VILLAGE OF ARLINGTON HEIGHTS **STAFF DEVELOPMENT** **COMMITTEE REPORT**

PC File Number: PC 18-025
Project Title: 1400 W. Thomas Subdivision
Address: 1400 W. Thomas Street
PIN: 03-19-107-005

To: Plan Commission
Prepared By: Jake Schmidt, Assistant Planner
Meeting Date: February 27, 2019
Date Prepared: February 19, 2019

Map 1 – Subdivisions within the Vicinity

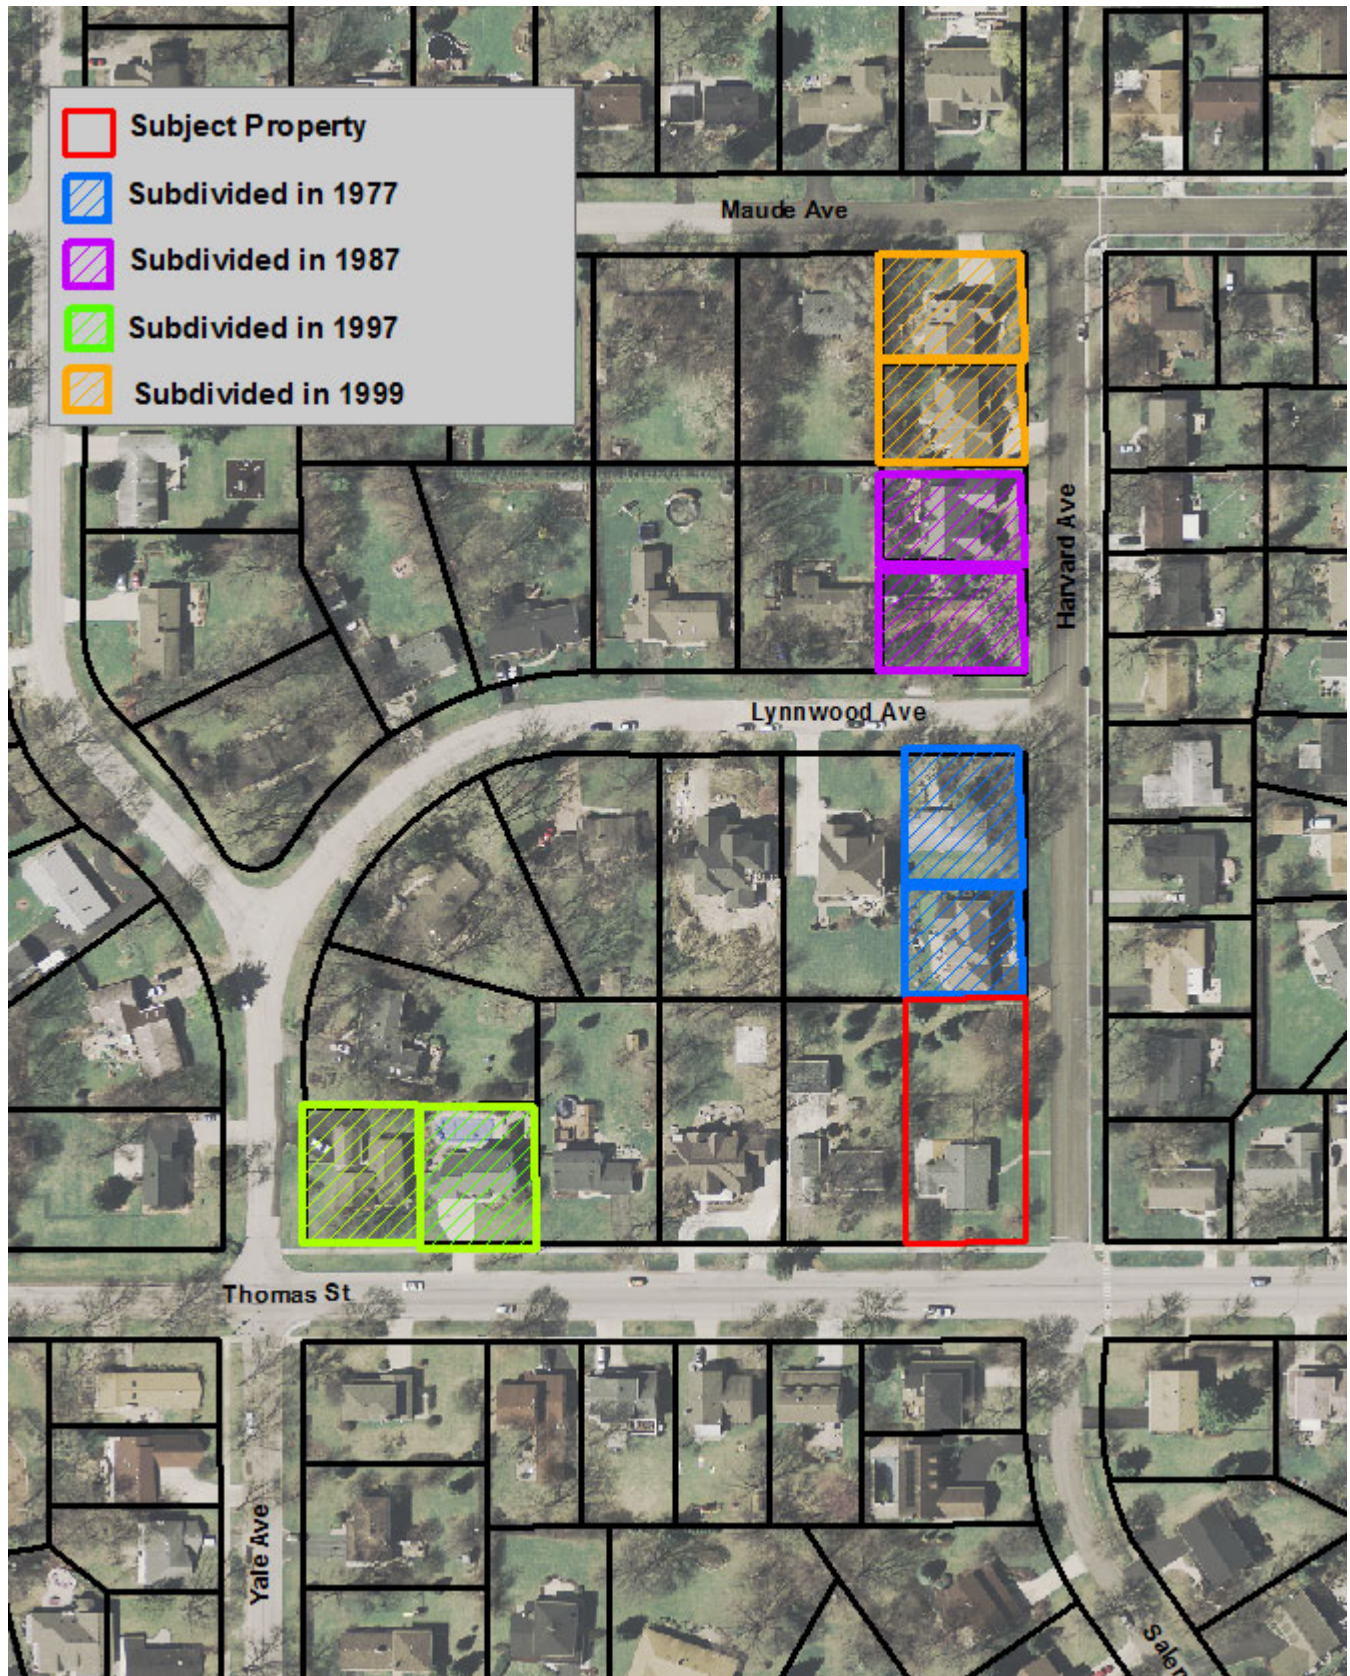
There have been several subdivisions within the vicinity of the subject site, similar to the requested subdivision, that have been approved over the last several decades. **Map 1** at the end of this report shows these subdivisions. It should be noted that all of these subdivisions occurred prior to the establishment of the R-E District and the *Single Family Detached Estate* residential classification within the Comprehensive Plan (2004). At the Conceptual Plan Review Committee meeting for this project, it was noted that the R-E District and *Single Family Detached Estate* classification were established following years of development, with sentiment at the time that larger lots such as the subject property should be preserved.

Map 3 – Existing Storm Sewer & Roadway Improvements

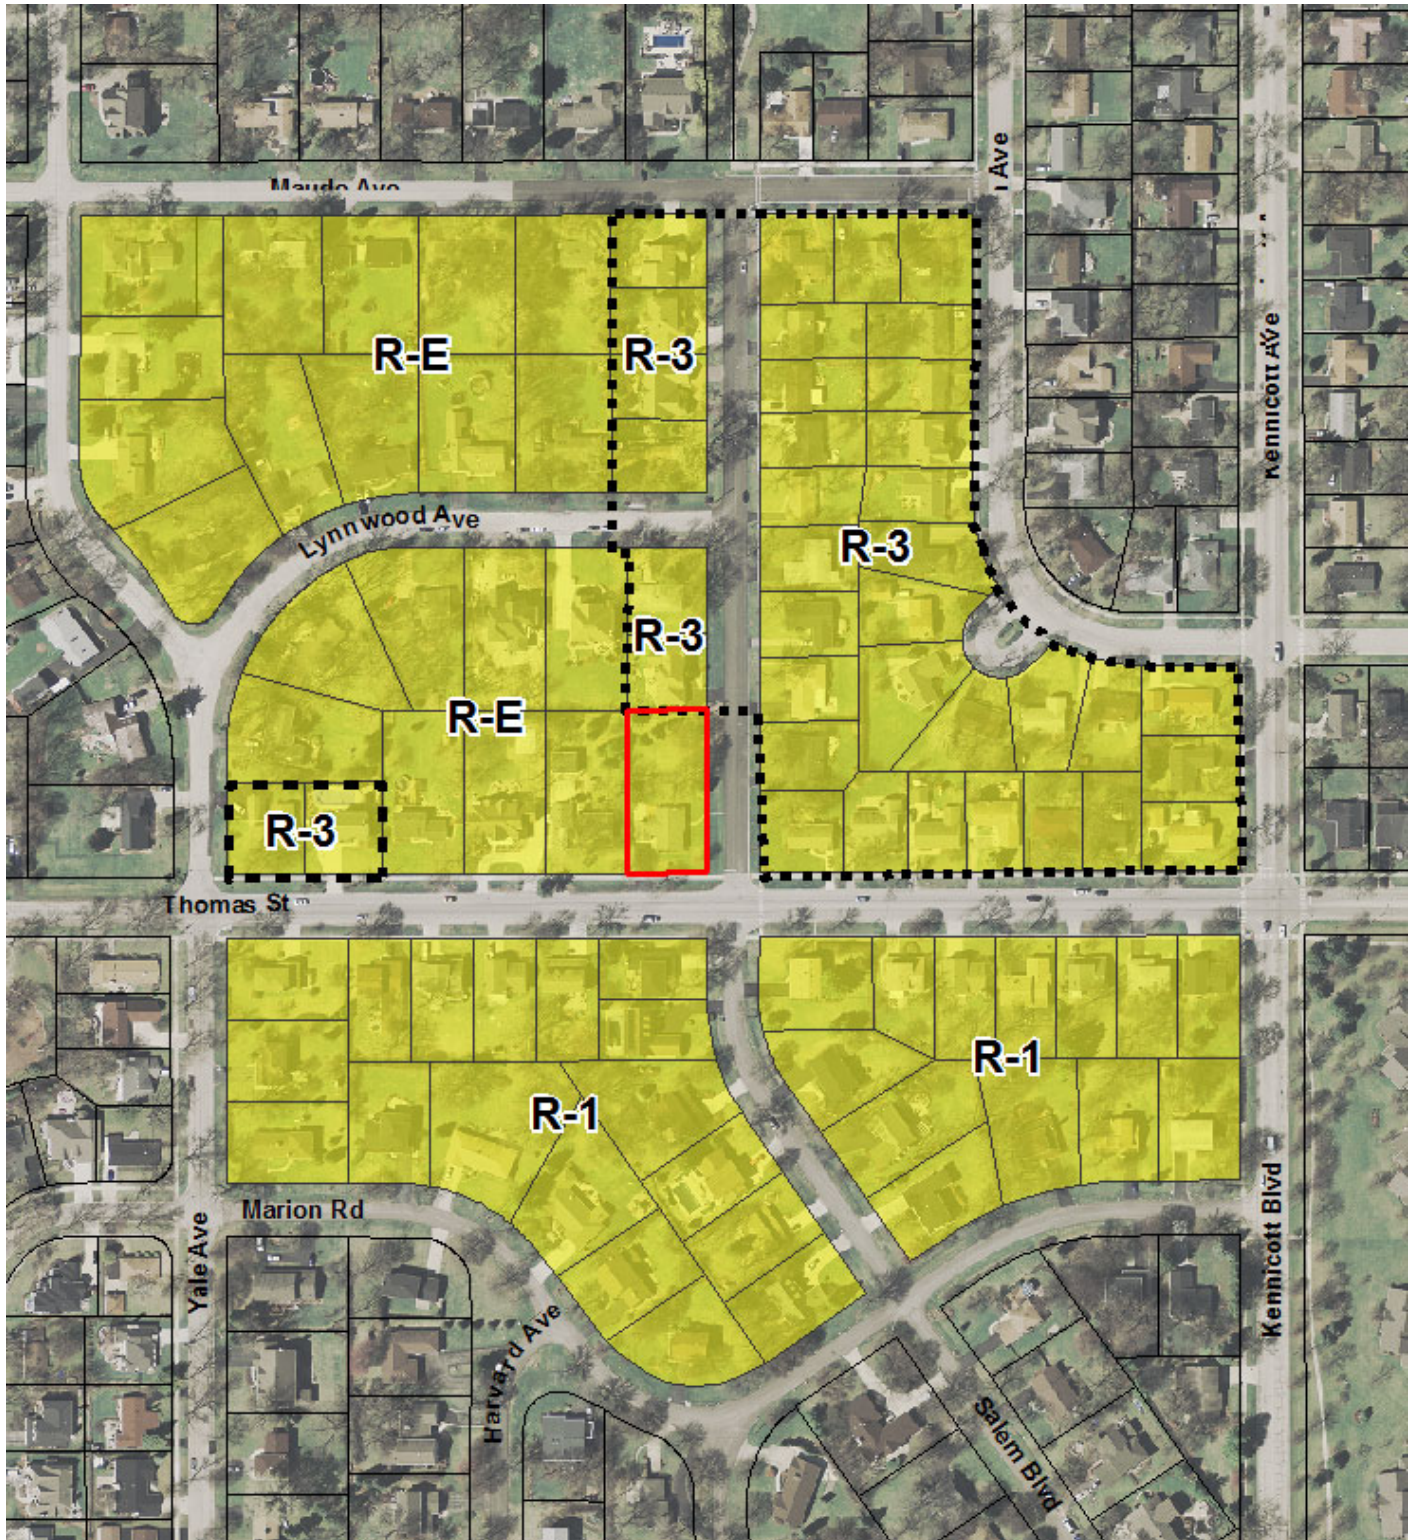
Staff has identified that sidewalk, curb & gutter, and storm sewer improvements are required along Harvard Avenue, in addition to curb & gutter and possibly storm sewer improvements along Thomas Street. Storm Sewer improvements along Thomas Street may be necessary after curb installation – those improvements consisting of an inlet near the corner, and a section of storm sewer to connect to the existing Village system.

The petitioner's engineer would have to make the final determination as to the necessity of the inlet. (**Map 3** at the end of this report shows the existing storm sewer, sidewalk, and curb & gutter adjacent to the subject site.) As part of the subdivision process, the petitioner has requested relief from the requirement to provide these improvements, at present or at a later date.

6. Prior to Final Plat Approval, the petitioner shall provide Final Engineering plans showing storm water infrastructure, such as a swale and inlet adjacent to Harvard Avenue connecting to the existing Village storm water system (or other engineering/infrastructure solution that will address necessary removal of storm water), as deemed acceptable by the Public Works Department and Engineering Division.
